Committee of the Whole Report For the Meeting of March 11, 2021

To: Committee of the Whole **Date:** February 25, 2021
From: Karen Hoese, Director, Sustainable Planning and Community Development
Subject: **Development Permit with Variances Application No. 000155 for 749-767 Douglas Street**

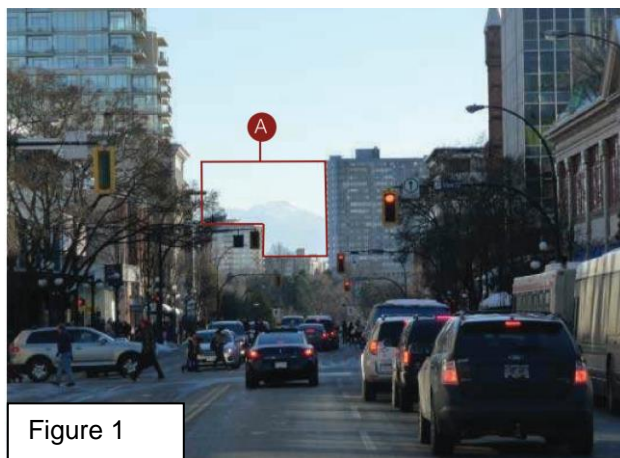
For the Douglas Street view corridor, the character defining element is the Olympic mountains. The proposed building massing reduces the Douglas Street view by approximately 56% (see Figure 1 below) and results in a requirement for an OCP amendment. It is important to note that, as the underlying zoning does not grant an “as-of-right” ability for a proposal to significantly affect a protected view, this would also be the case for an application that was wholly consistent with the existing zone, but still infringed into this view corridor.

Despite this infringement into the Olympic Mountain view corridor, design changes can alleviate the impact, while still achieving building separation standards. The proposal includes a building separation of 22m to the building to the east, while policy calls for between 3m and 6m. Shifting the proposal by approximately 10m to the east would improve this view corridor, helping frame the view as suggested in the OCP, and maintaining a greater separation distance between buildings than required under policy. It would also free up additional space for street trees at the ground level to further enhance the public realm.

- a) reduce the infringement into View 5: Olympic Mountains from Douglas Street by setting the building back approximately 10m from the west property line
- b) increase the proposal's consistency with design guidelines pertaining to form, character, exterior design and finishes, particularly with respect to the flat façade and cladding material
- c) commit to meeting Step 3 BC Building Code requirements.

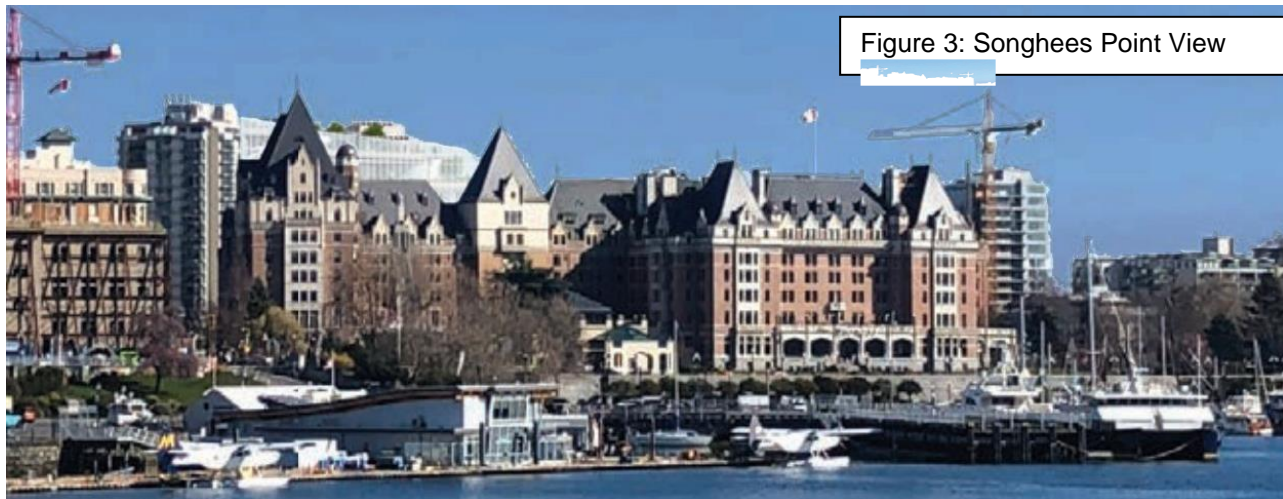
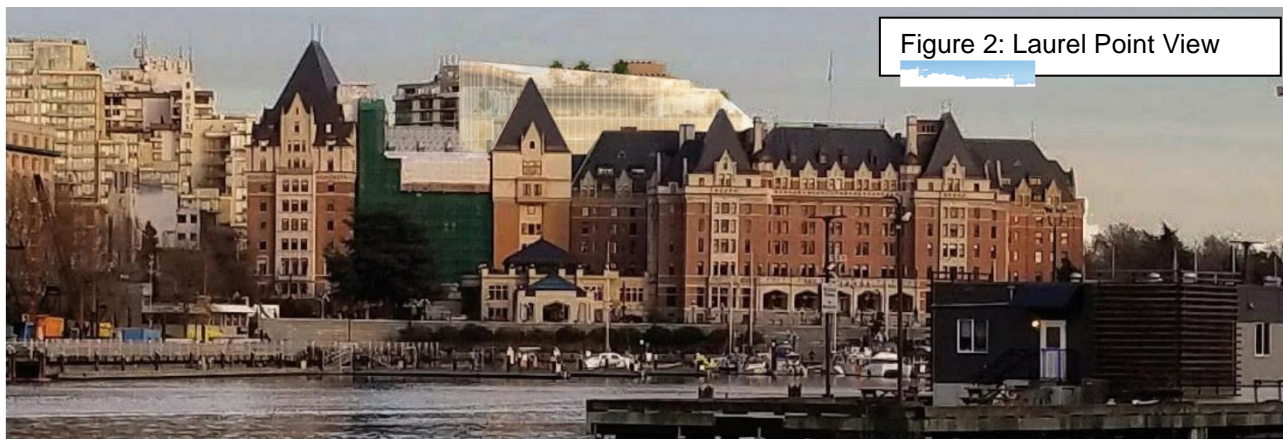
From the Laurel Point and Songhees vantage points, the character defining element is the Empress Hotel and its relationship to its context. For these views, the proposal appears above the Empress roofline (see Figure 2 and 3 below), but the actual view is not infringed on or reduced. Some of the DCAP view guidelines that pertain to the relationship between new and existing buildings include:

The ability to maintain the general moderate scale and visual role of supporting background buildings is impacted with the introduction of a large building mass behind the Empress. Blocking the visual diversity behind the Empress with a similarly long building may compete with and diminish the Empress's visual prominence rather than protect it. Reducing the length of building that appears behind the Empress, introducing a taller and narrower massing, similar to the existing background context, or utilizing design strategies to break up the proposed building mass might help to address this condition.

With regard to objectives to ensure lighting does not detract from evening view of the Empress, the applicant has removed the illuminated building logo that was initially proposed to be visible above the Empress roof line. This is of benefit to the protected Laurel Point View, however, given the glass façade and proximity of the proposed building, evening lighting within the building may detract from the architectural lighting of the Empress Hotel.

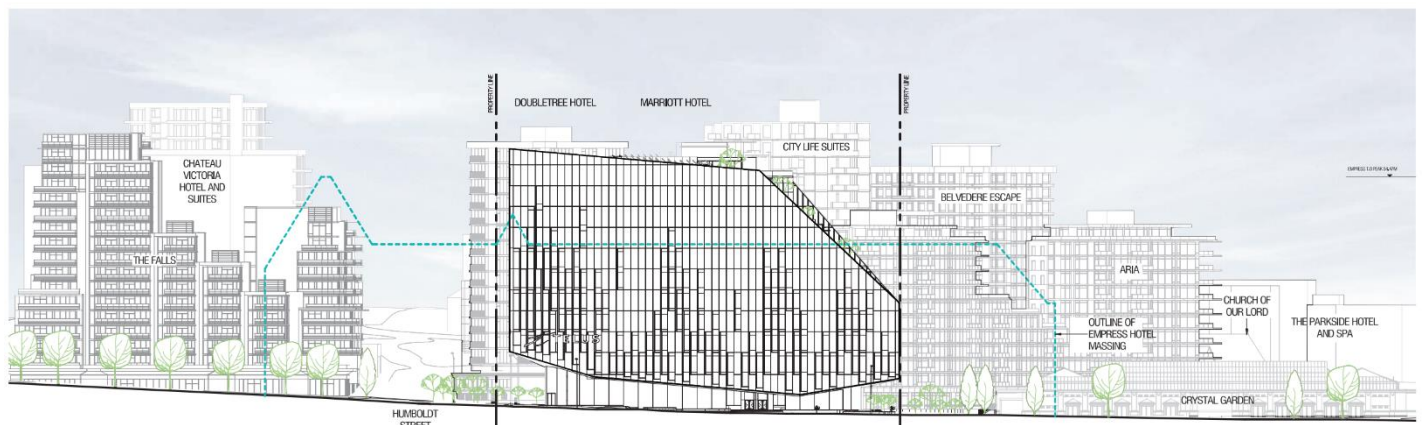
A 5:1 setback plane, above ten metres, establishes a setback line that proposed buildings must not infringe on. The intent of this setback is to mitigate density and height impacts, reduce building bulk of upper storeys, to minimize the effects of shading and wind vortices and to maintain views to the open sky. At the upper most storey, this would result in a setback of nearly nine metres from the property line. As discussed in the rezoning report, the proposal infringes into this setback by seven metres and conflicts with the protected view corridor policies.

The wind study provided (attached) also identifies areas of the pedestrian realm that may experience wind speeds in excess of the safety criteria. As noted, building setbacks (as well as building articulation, wind screens and planting) can mitigate wind vortices. Further refinements to the proposal would help to address this concern.
